# Modifications for the Kenwood TS-450

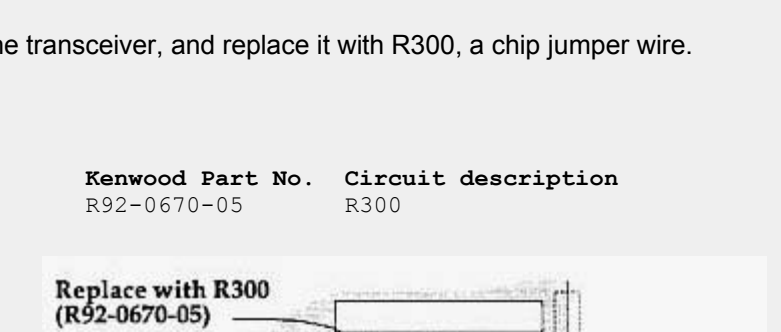
We have received several reports of distorted transmitter audio when using a TNC controller such as the AEA PK-232 or Kantronic KAM, etc. The symptom will generally disappear if the transceiver and TNC units are powered from different sources.

Cause:  
The audio output level from the TNC is generally too high and causes overload of the microphone amplifier circuit. In previous models such as the TS-440S the incoming TNC audio was inserted after the microphone amplifier. With the TS-850S it is inserted before the microphone amplifier. Just moving the insertion point to the output of the circuit is satisfactory since the drive level for FM packet is higher than that required for SSB.

Procedure:  
1. Add a 10 dB attenuator to the PKD line on the IF unit (X48-3090-XX). This will prevent overmodulation of the microphone input circuit.  
a. Change chip resistor R233 from 10 Kohm to 18 Kohm (RK73FB2A183J)  
b. Change chip resistor R234 from 1 Kohm to 8.2 Kohm (RK73FB2A822J).  
c. Delete chip capacitor C173 (100 pF) and add chip resistor R299, 1.5 Kohm (RK73FB2A152J).
